SUBJECT: NuScale Power, LLC Response to NRC Request for Additional Information No. 473 (eRAI No. 9483) on the NuScale Design Certification Application

REFERENCE: U.S. Nuclear Regulatory Commission, "Request for Additional Information No. 473 (eRAI No. 9483)," dated May 11, 2018

Response to Request for Additional Information Docket No. 52-048

eRAI No.: 9483

Figure 15.1-54: Core Outlet Temperature (15.1.1 Decrease in Feedwater Temperature)

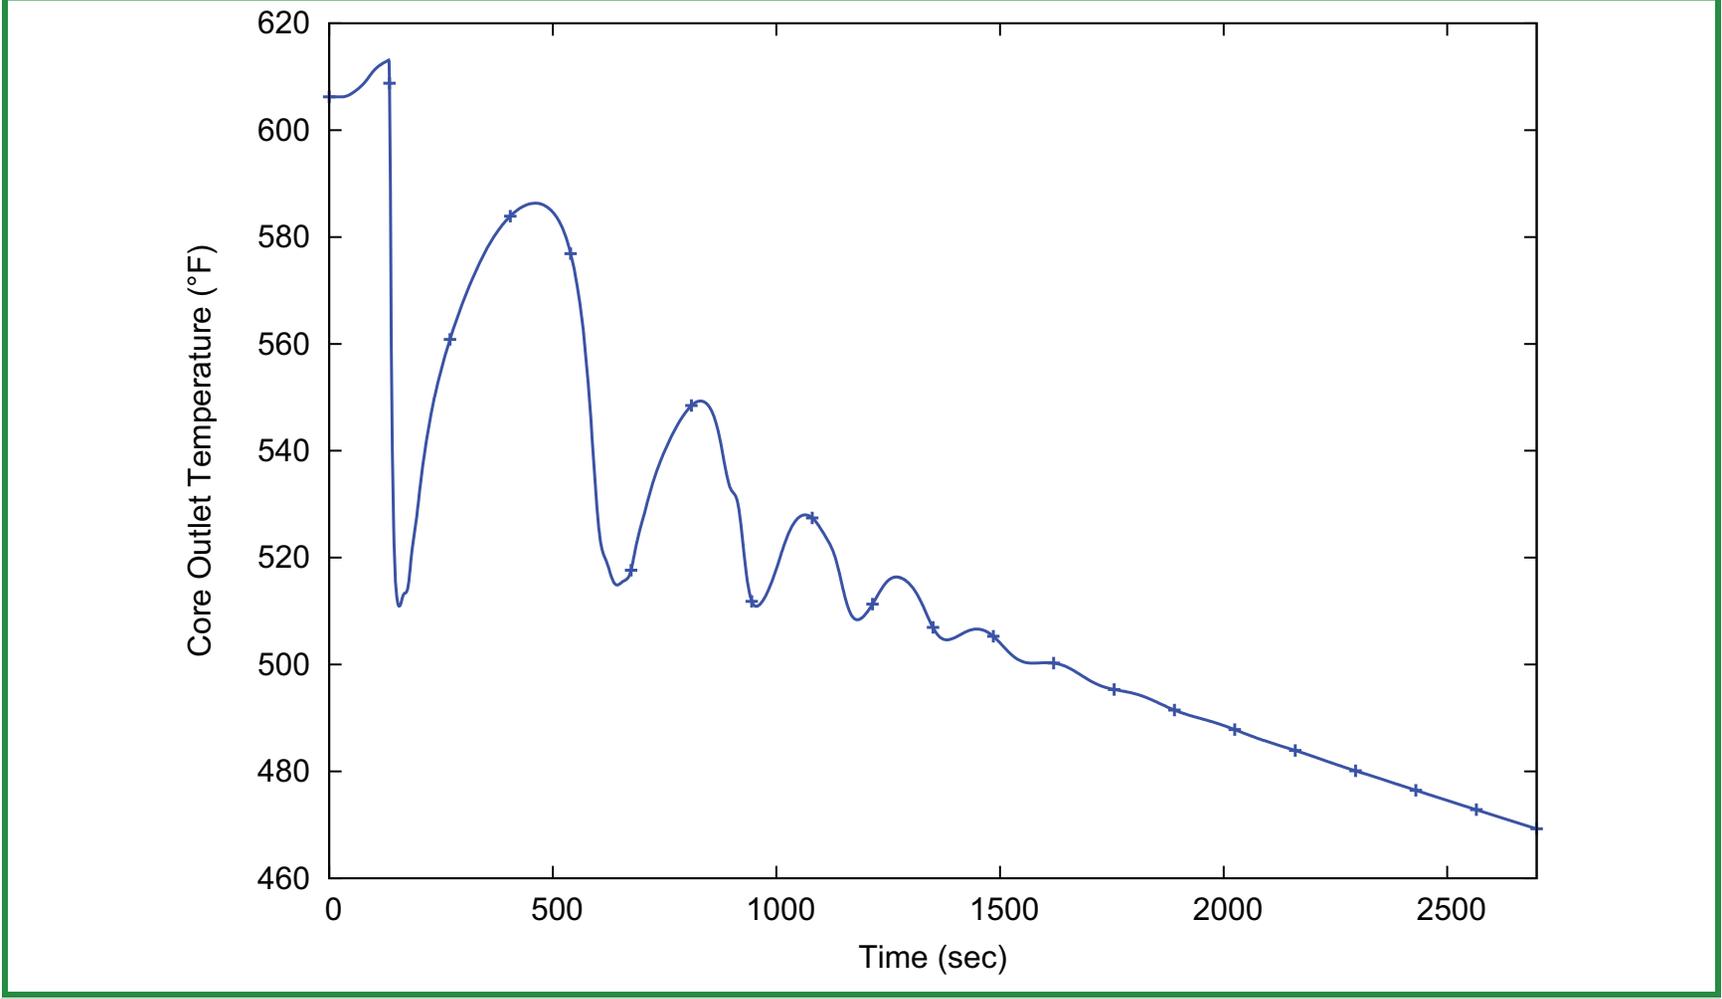
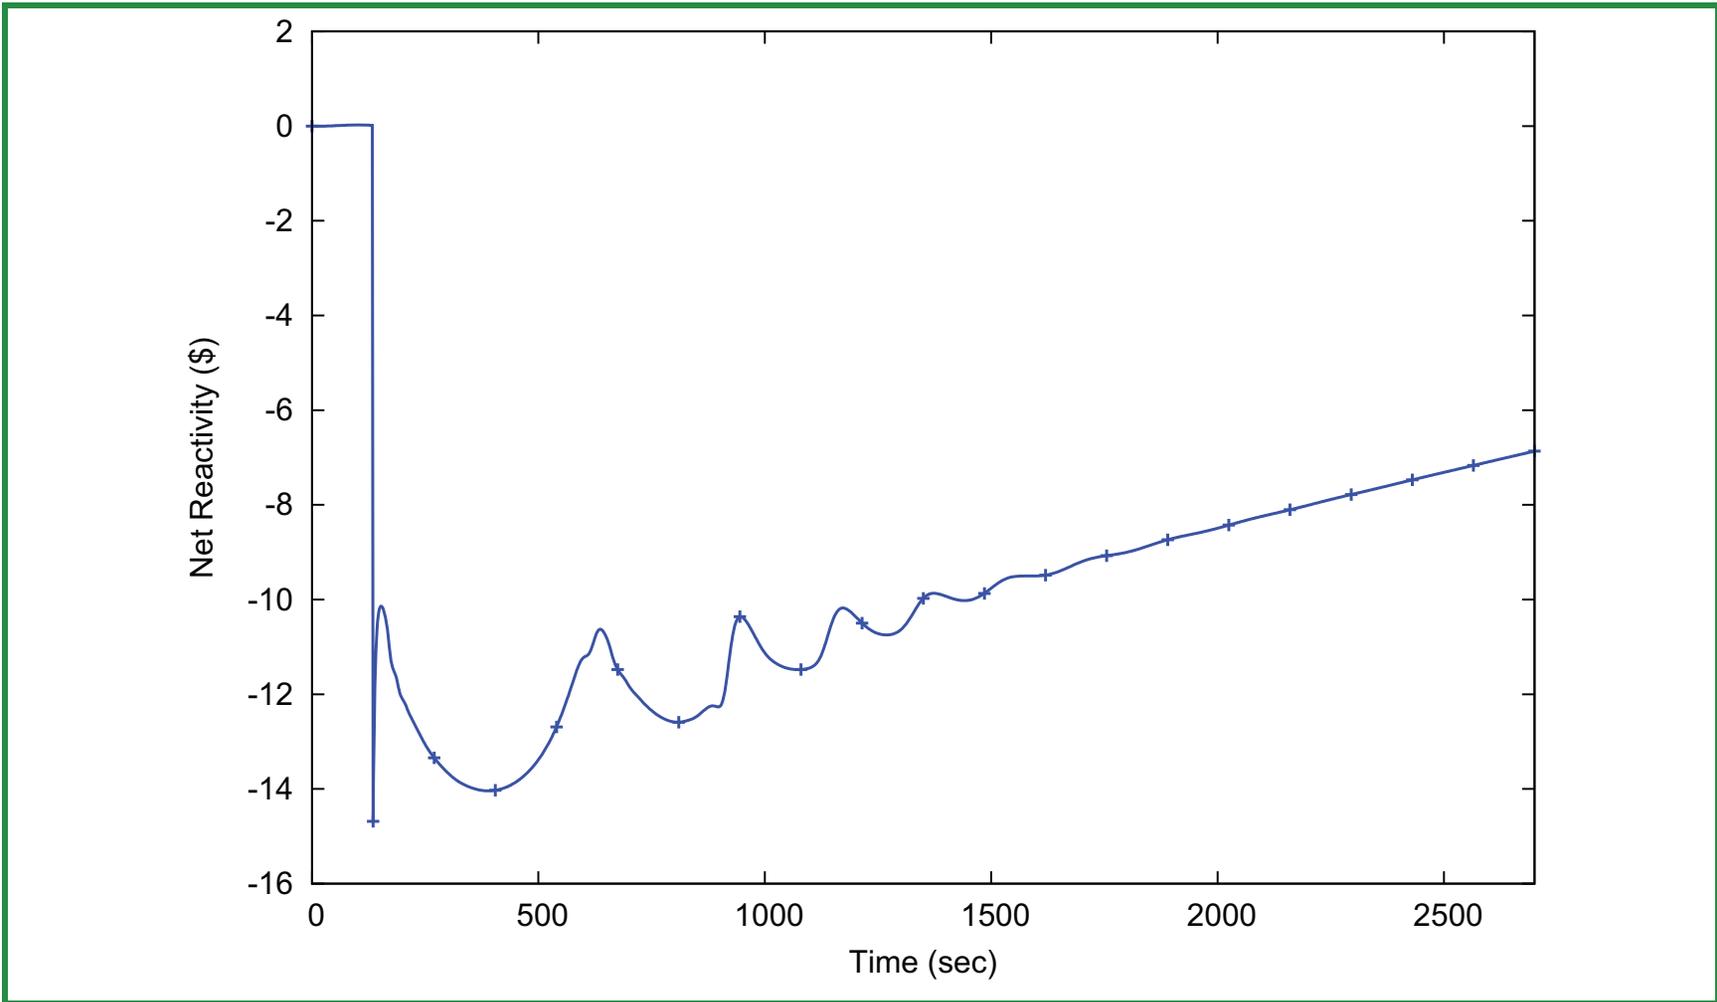
- All core outlet temperature figures for FSAR Sections 15.1.1-15.1.3 (Figures 15.1-7, 15.1-17, and 15.1-28); alternatively, a figure of core average temperature for each event
- All total core reactivity figures for FSAR Sections 15.1.1-15.1.3 (Figures 15.1-4, 15.1-14, and 15.1-25)
- Reactor coolant system pressure for FSAR Section 15.1.3 (Figure 15.1-27)

Core outlet temperature and core reactivity plots that span the entire transient have been added to FSAR Section 15.1 for the following events: decrease in feedwater temperature, increase in feedwater flow, and increase in steam flow. The reactor coolant system pressure plot was added to FSAR Section 15.1 for the increase in steam flow event.

FSAR Section 15.1 and FSAR Figure 15.1-54 through Figure 15.1-60 have been revised as described in the response above and as shown in the markup provided with this response.

Figure 15.1-22: Steam Flow (15.1.3.2 Increase in Steam Flow)

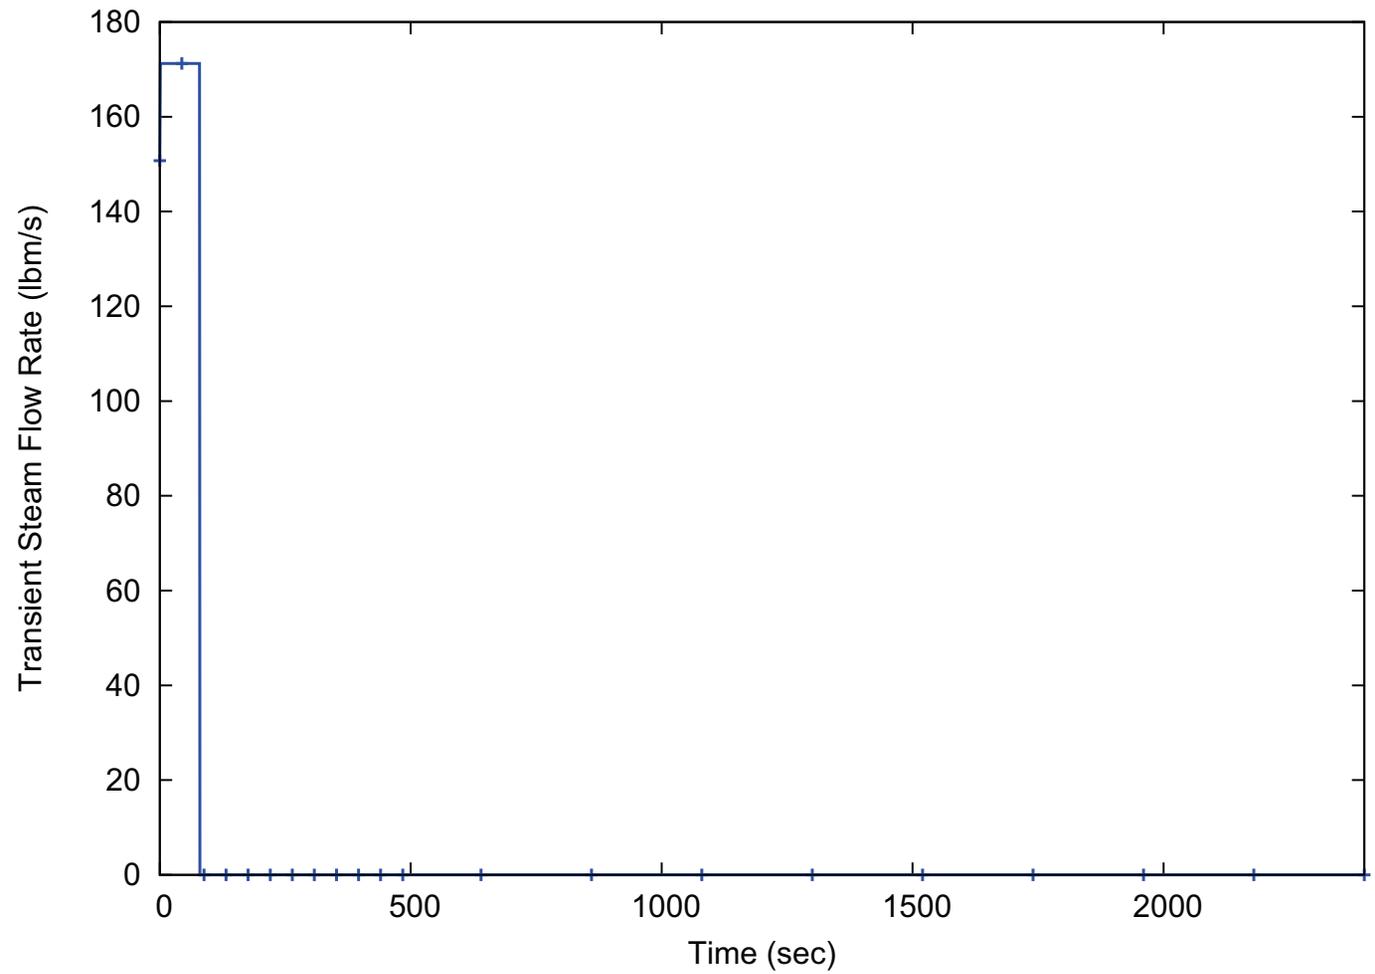
- FSAR Tier 2, Table 15.1-5, "Sequence of Events (15.1.3 Increase in Steam Flow)," shows that the reactor trips on high hot leg temperature instantaneously instead of after the 8-second actuation delay specified in FSAR Tier 2, Table 15.0-7.
- FSAR Tier 2, Table 15.1-6, "Increase in Steam Flow - Inputs (Limiting Minimum Critical Heat Flux Ratio Case)," lists SG temperature as a parameter, when it appears it should be SG pressure.
- Figure 15.1-22, "Steam Flow (15.1.2 Increase in Steam Flow)," appears to be mistitled since the increase in steam flow event is described in FSAR Section 15.1.3.
- FSAR Tier 2, Figure 15.1-26 appears to be mistitled, as it shows reactor power but is titled "Total Core Reactivity."

The remaining errors identified in this request for additional information have been corrected as shown in the markup with this response.

FSAR Section 15.1.1, Section 15.1.2, Section 15.1.3, Table 15.1-7, Table 15.1-8, Figure 15.1-22, and Figure 15.1-26 have been revised as described in the response above and as shown in the markup provided with this response.
